Planning Commission MEETING AGENDA

Thursday, November 17, 2022 - 1:00 PM
Council Chambers, Easton Town Office
14 S Harrison Street

**PLANNING COMMISSION
PUBLIC HEARING
STAFF REPORT**

SUBJECT: Sketch Site Plan Review for 521 August Street (41 N. Park Street – Pending New Address)

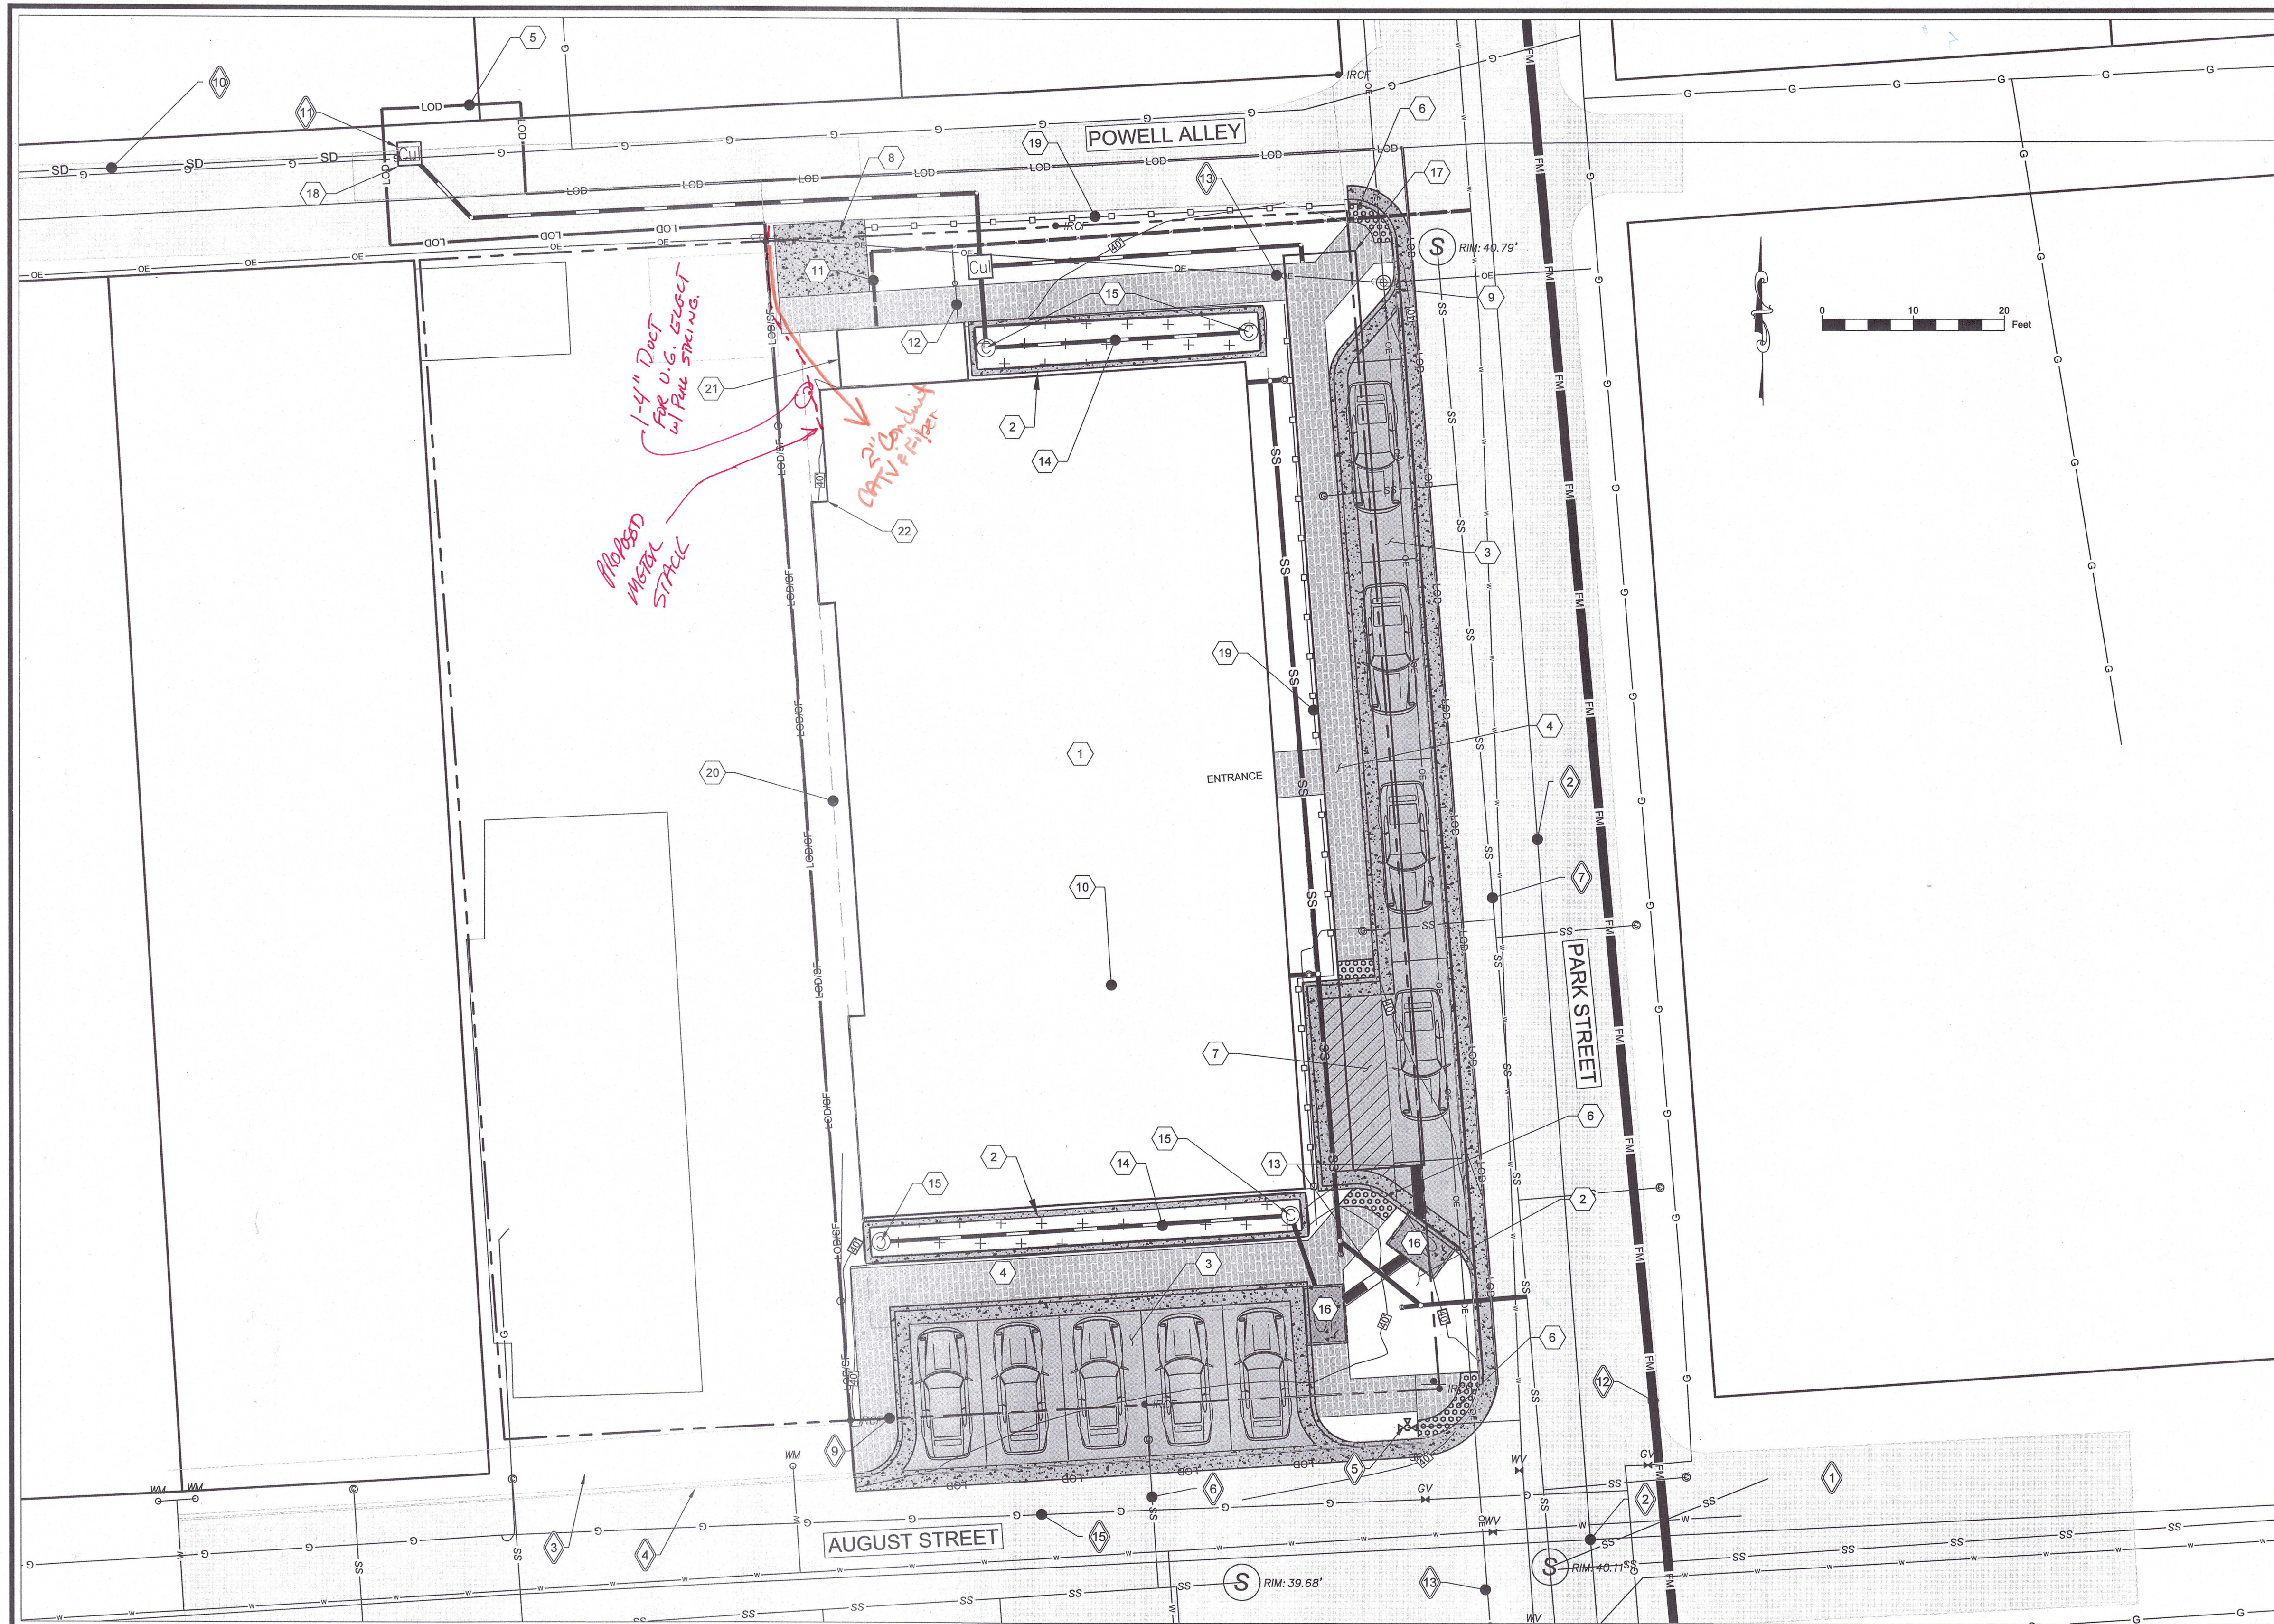
ITEM:	DRAWING / PAGE	COMMENTS:
1	C-101	Install 2" conduit for CATV & Fiber Communications
2	General	If entrance is on Park St. side, address will need to be changed.
3	V-100	Lot Line Adjustment required, Plans approved as noted (existing features: Comment #7)

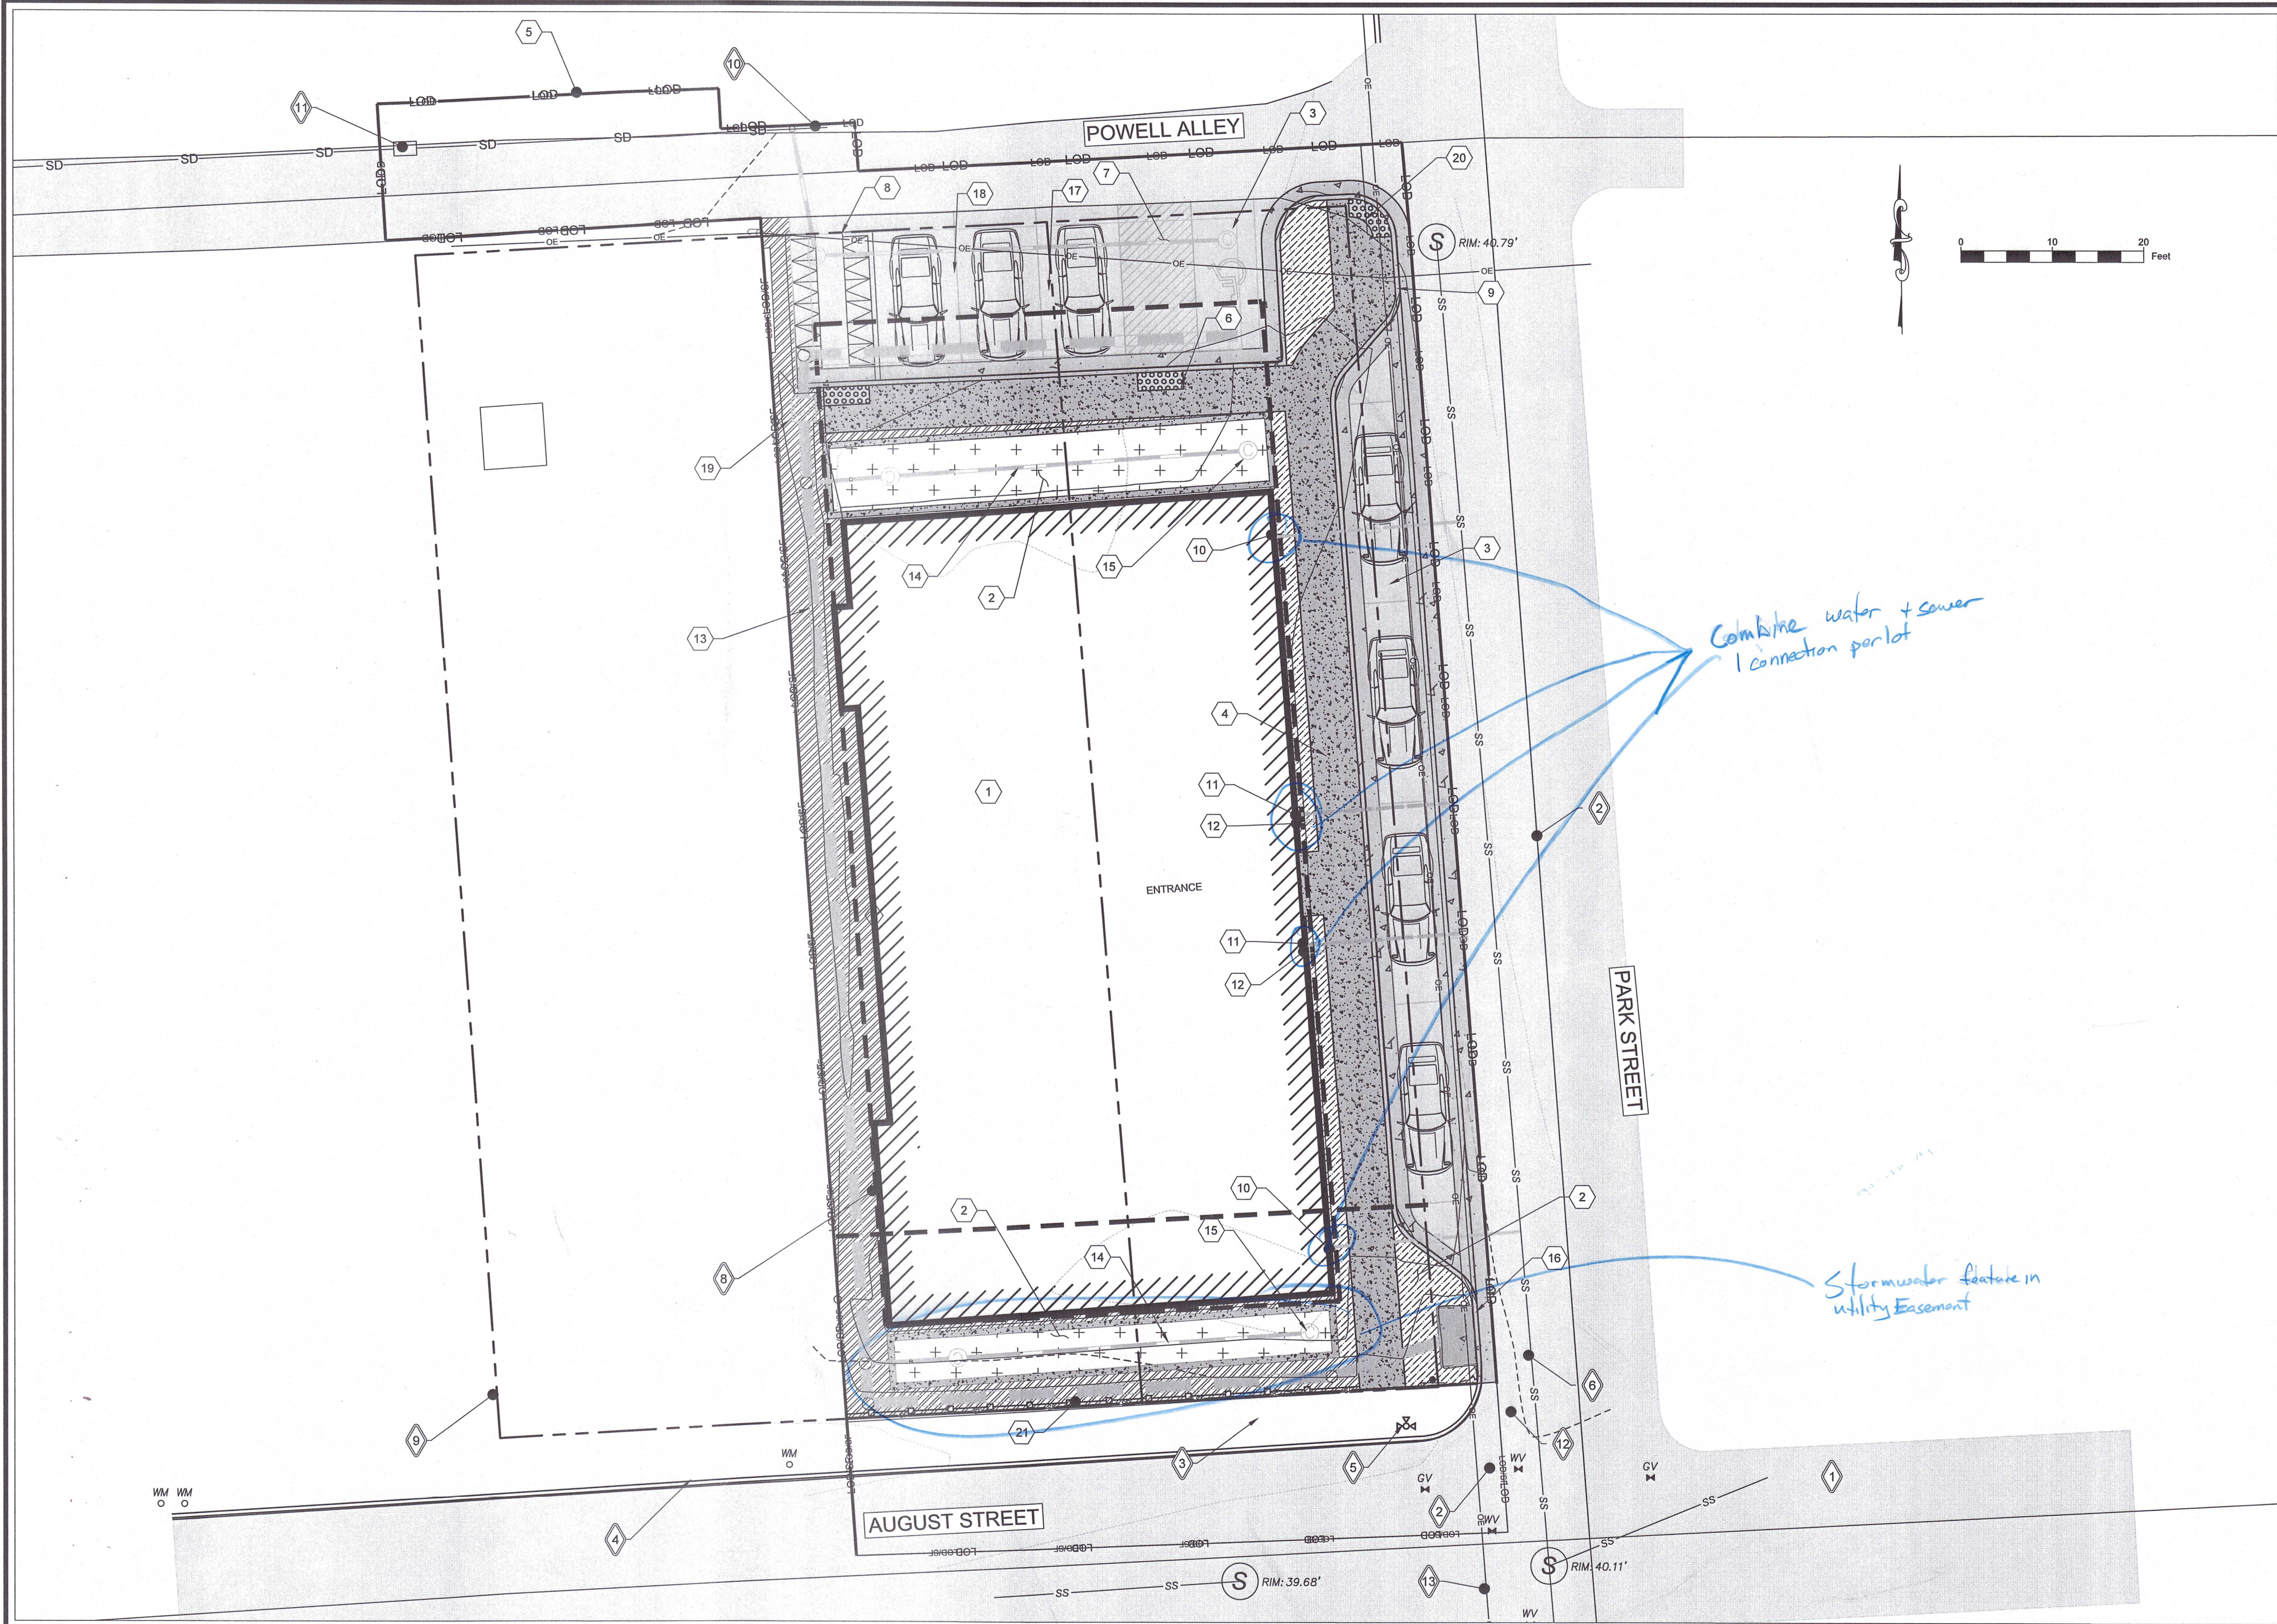
2. **SHEET C-101** – Show the existing structure on the property west of the proposed building.
3. **SHEET C-101** – The existing August Street sidewalk must be maintained/reconstructed to make it level and ADA compliant. The reconstructed sidewalk should be brick or pervious brick pavers.

4. **SHEET C-101** – Park Street Parking is partially on private property. A lot line revision, license agreement, or some other agreement is required.

5. **SHEET C-101** – Proposed sidewalk on Park Street should be brick or pervious brick pavers to be consistent with August Street. This sidewalk should be for public use and should either be in Town ROW or in an easement.
